Project	<b>IEEE 802.16 Broadband Wireless Access Working Group</b> < <a href="http://ieee802.org/16">http://ieee802.org/16</a> >	
Title	<b>FFT size and subchannelization for scalability</b>	
Date Submitted	<b>2004-05-15</b>	
Source(s)	Jeong-Heon Kim, Jiho Jang, Panyuh Joo, Jaeho Jeon, Soon Young Yoon  Samsung Electronics Co., Ltd. Dong Suwon P.O.Box 105 416, Maetan-3dong, Yeongtong-gu, Suwon-city, Gyeonggi-do, Korea 442-600	<a href="mailto:jeongheon.kim@samsung.com">jeongheon.kim@samsung.com</a> <a href="mailto:jiho.jang@samsung.com">jiho.jang@samsung.com</a> <a href="mailto:panyuh@samsung.com">panyuh@samsung.com</a> <a href="mailto:jhjeon@samsung.com">jhjeon@samsung.com</a> <a href="mailto:soon.young.yoon@samsung.com">soon.young.yoon@samsung.com</a>
Re:	Contribution supporting Sponsor ballot	
Abstract	System parameters to support public cellular operation and scalability	
Purpose	Adopting of proposed system parameters into P802.16e

## FFT size and subchannelization for scalability

**Table 15. 1024-FFT OFDMA AMC carrier allocations**

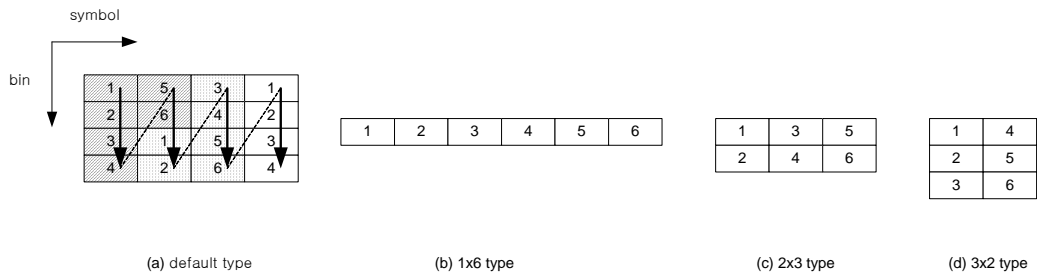
(6) ADD the following tables at ‘Section 8.4.6.3 Optional permutations for AAS and AMC subchannels’

<u>Parameters</u>	<u>Value</u>	<u>Comments</u>
<u>Number of DC Subcarriers</u>	<u>1</u>	
<u>Number of Guard Subcarriers, Left</u>	<u>80</u>	
<u>Number of Guard Subcarriers, Right</u>	<u>79</u>	
<u>Number of Used Subcarriers (<math>N_{used}</math>)</u> (including all possible allocated pilots and the DC carrier)	<u>865</u>	
<u>Number of Pilot Subcarriers</u>	<u>96</u>	
<u>Pilot Subcarrier Index</u>	<u><math>9k+3m+1</math>,</u>	<u>Symbol of index 0 is the first AMC data symbol in the</u>

<u>for k=0,1,.....,95 and m=[symbol index] mod 3</u>	<u>downlink or uplink.</u>
<u>Number of Data Subcarriers</u>	<u>768</u>	
<u>Number of Bands</u>	<u>24</u>	
<u>Number of Bins per Band</u>	<u>4</u>	
<u>Number of Data Subcarriers per Subchannel</u>	<u>48</u>
